Recall Campaign Bulletin

Campaign No. 2023100014, November 2023

SUBJECT: **Model SL (232 platform)**
Model Year 2022-2023

Inspect 12V Starter/Alternator Wiring Harness

Figure 1: Inspect starter/alternator wiring harness near propeller shaft (**arrow A**), direction of travel (**arrow B**)

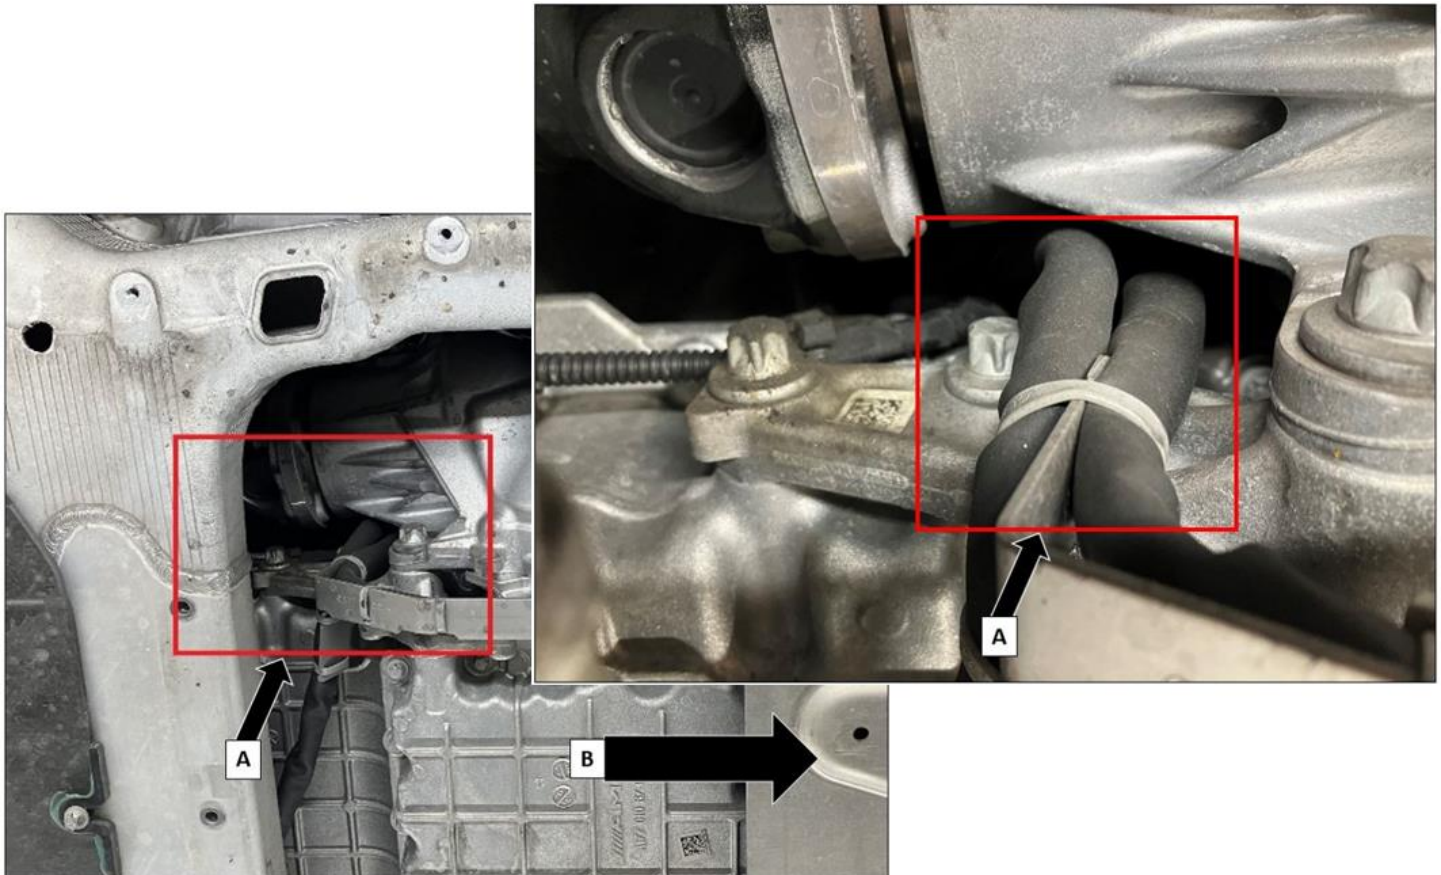
2. Check if the 12V starter/alternator wiring harness is too close to the propeller shaft and inspect it for damage near the propeller shaft (**A, Figure 1**).

- a. Starter/alternator wiring harness **not damaged**, carry out **Work Procedure 1**.
- b. Starter/alternator wiring harness **damaged**, carry out **Work Procedure 2**.

Figure 2: Install cable tie on starter/alternator wiring harness

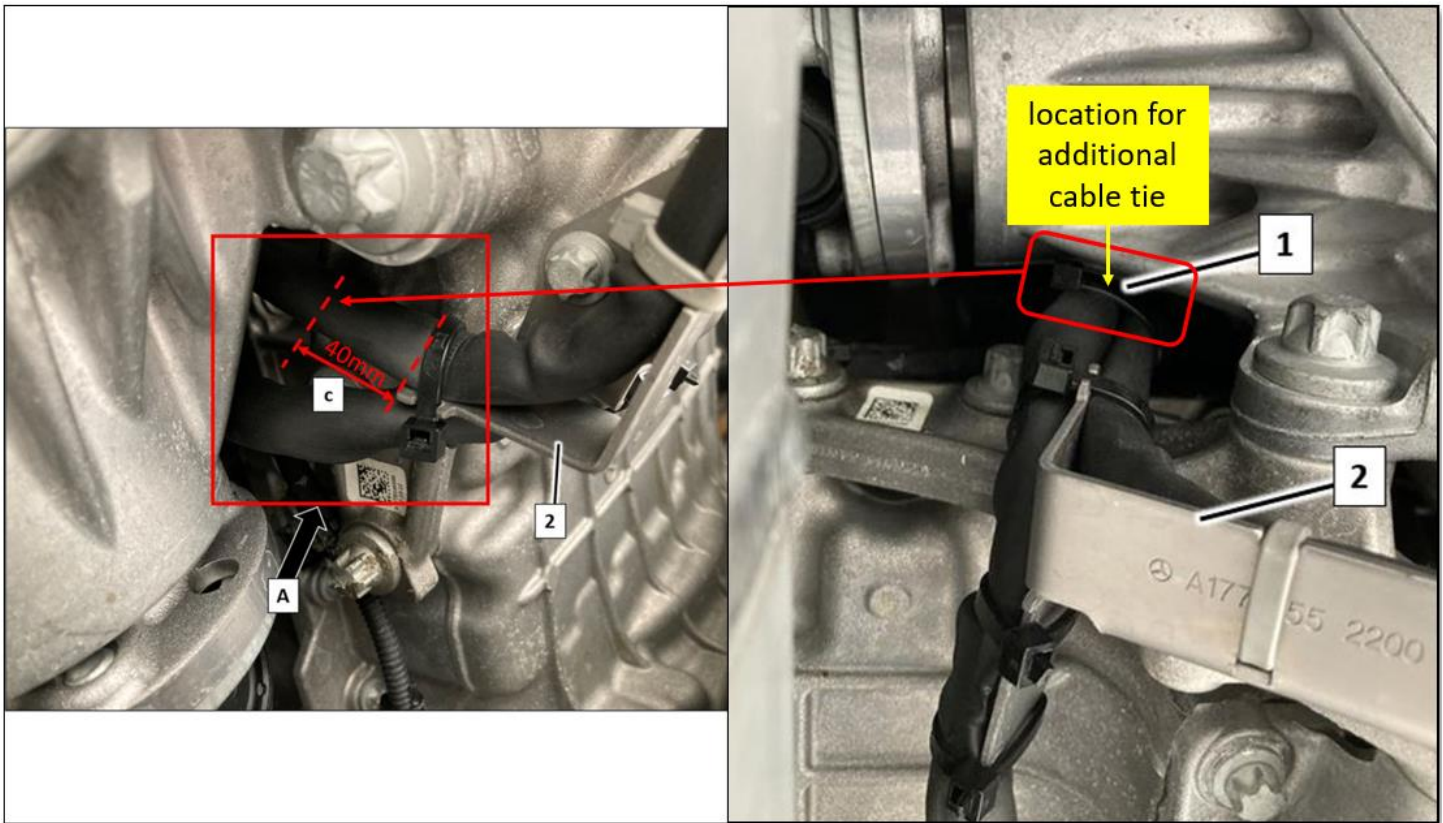
1. If the starter/alternator wiring harness is **not damaged**, install an additional cable tie (1, **Figure 2**) in area near the propeller shaft at approx. 40 mm (**dimension c, Figure 2**) above the bracket (2, **Figure 2**).
